**Cumberland County Subdivision and Land Development Review Report**

| Plat Title:       | <u>David and Carol Adams</u> |                             |                               |                                      |                             |
| Plat Status:      | <u>Final</u>                 | Plat Type:                  | <u>Subdivision</u>            |                                      |                             |

**FINAL SUBDIVISION PLAN FOR  
DAVID W. &  
CAROL A. ADAMS**

| Sheet No.    | SD - 2          |

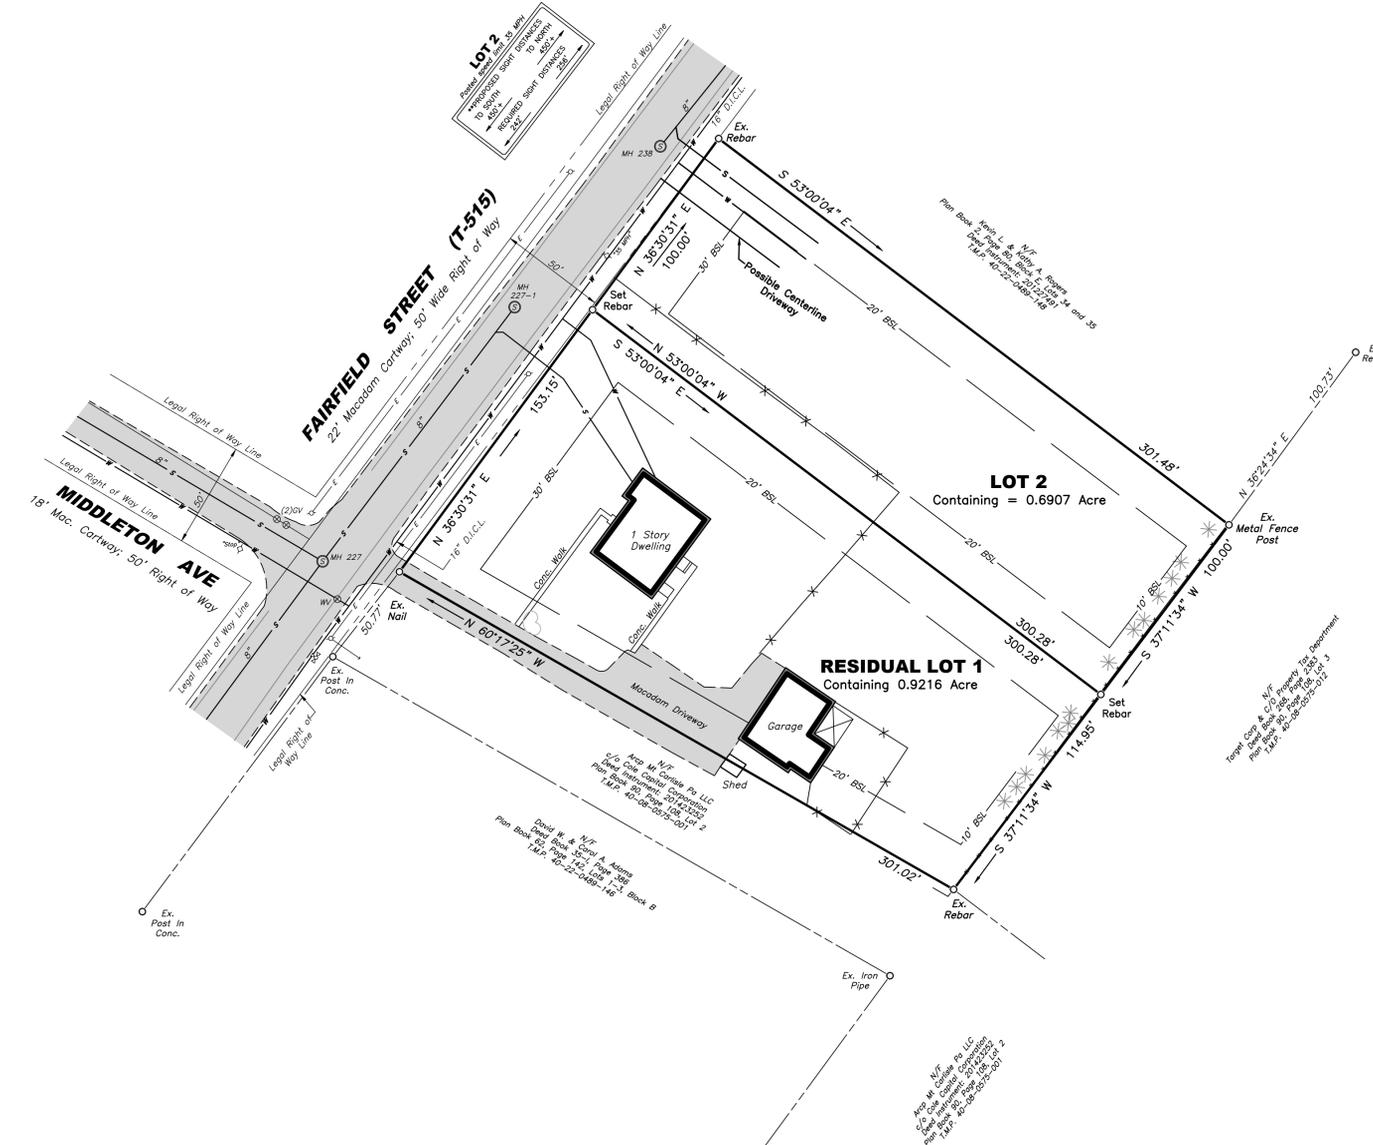
1. The Zoning District requirements on the plan should be verified. It appears that the rear yard should be 20 feet and the side yard should be 10 feet (Zoning 903.1.a).

3. The plan should provide proof of compliance (proposed dimensions) with all applicable zoning requirements (SLDO 501.B.12).
4. The plan should address the Pennsylvania DEP sewage planning requirements (SLDO 502.B).

5. Sidewalks, curbs and gutters should be provided (SLDO 707-708).
6. Street Trees should be provided (SLDO 711.B.2.G).
7. It appears that the existing wood fence will occupy both lots. The Township may want to recommend relocation of the fence or reconfiguration of the proposed lot line.

8. The existing macadam driveway appears to be shared with the adjacent property. The plan should reference a recorded joint use and maintenance agreement.
